Re: Case reference: 314232 -Railway Order Application DART+ West Railway Order - Dublin City to Maynooth and M3 Parkway

I am writing to submit my observations on the DART+ West Electrified Railway Order 2022 (Case reference: NA29S.314232).

1. Proposed substation in Glendale Estate

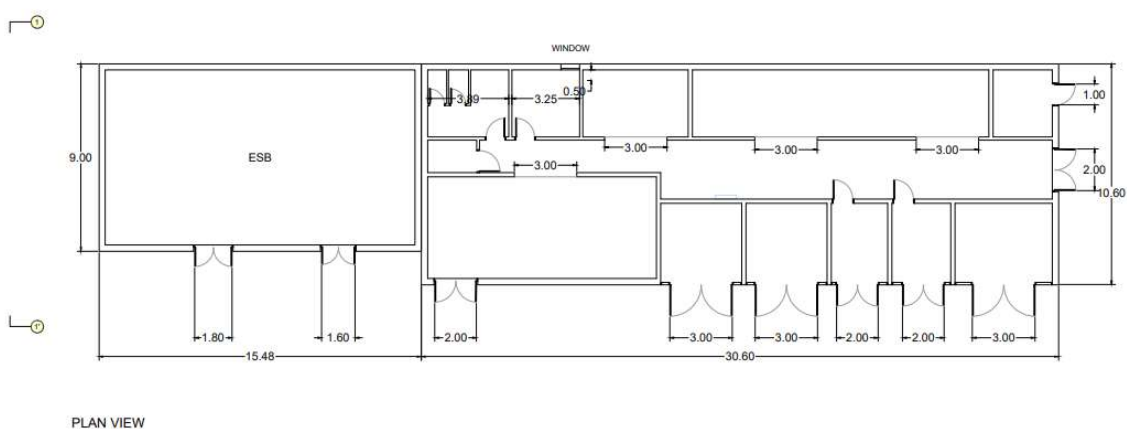
I also note that even though CIÉ do own land along the boundary of the train line, as marked in pink in the above, the proposed location of the substation is completely on the green area that is privately owned and used by residents. The reason for this is unclear given that at other stations, the substation is proposed to be far closer to the railway line e.g. Ashtown. Even if the substation were to be moved closer to the train line, issues would still remain regarding:

- the use of a green area in a residential development for an industrial building,
- the incongruous design which would dominate the green area,

- the dangers posed by introducing industrial traffic on a regular basis into a residential estate, including the crossing with an established pathway, and the interaction between the proposed access road and green recreational area, and
- the removal of mature trees.

Therefore, there are many reasons why the current proposal is unsuitable. These largely stem from the fact that the proposed location is on a green recreational area in a residential development that was never intended for nor is suitable for an industrial building or industrial traffic. For that reason, I would urge An Bord Pleanála to re-examine the first option of locating the substation within the grounds of Leixlip Confey train station. It is naturally more suitable and offers many advantages including:

2. Construction Compound on Glendale Estate Green

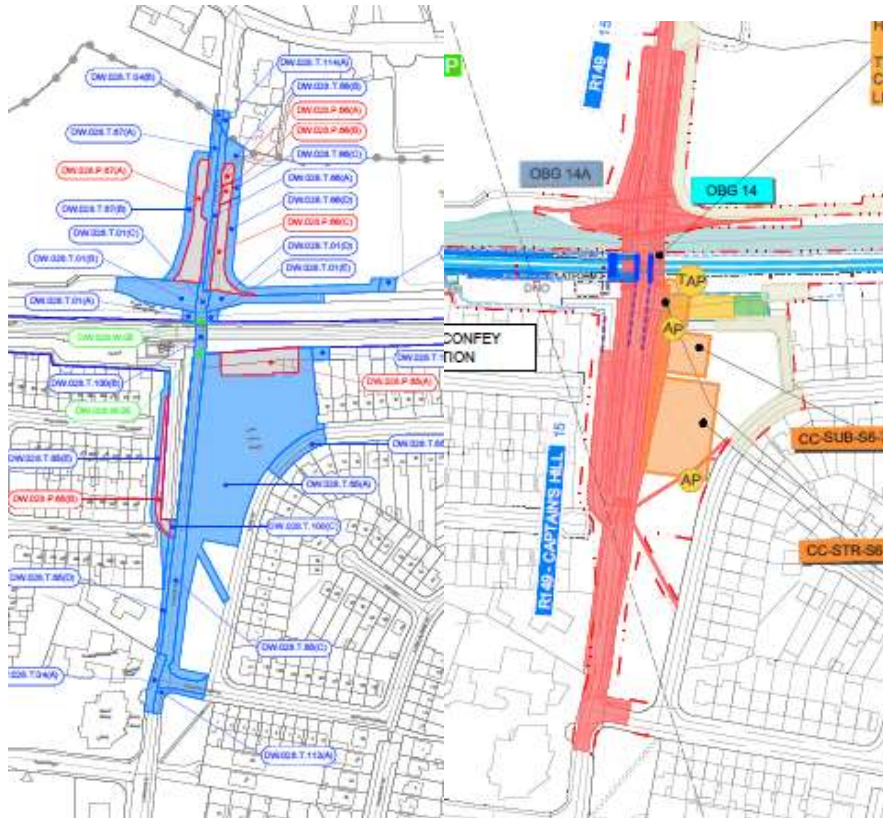
In addition to the proposal to locate the substation, a permanent structure, on the green at Glendale Estate, there is also a proposal to take over a large portion of the green area on a temporary basis for a construction compound. This temporary basis is I understand it several years in duration. This would destroy much of the grass, flora and fauna, which would take years to recover. It would also significantly reduce the usable space for residents with a very large portion converted to a construction site. As a result, it would become extremely unattractive as a recreational area, and therefore in all likelihood the entire green would become unusable. I consider this to be an unacceptable level of impact on residents. The green area is a recreational space, which the residents have been caring for, for over 40 years. It is an area for children to play on and for residents to enjoy. It is located in a residential development, and is not suitable for accommodating construction traffic.

I could not locate full details of the planned use of the construction compound and if it would be intended to be accessed by construction vehicles – if so, the intended access point has not been made clear, but presumably it would be from within the estate. The estate road is completely unsuitable for such traffic in terms of volume and size. It was never designed to take heavy vehicles on a regular basis, and it cannot accommodate them. Alternatives should be sought such as the land at the train station, and/or the vacant site on the far side of the canal which has been recently used for development work and could accommodate construction traffic and materials with far less impact on residents. I could not find evidence that this has been considered, but given that the site has already been used for development, I would presume the landowner would again be open to this. This would be far more suitable and safer for all.
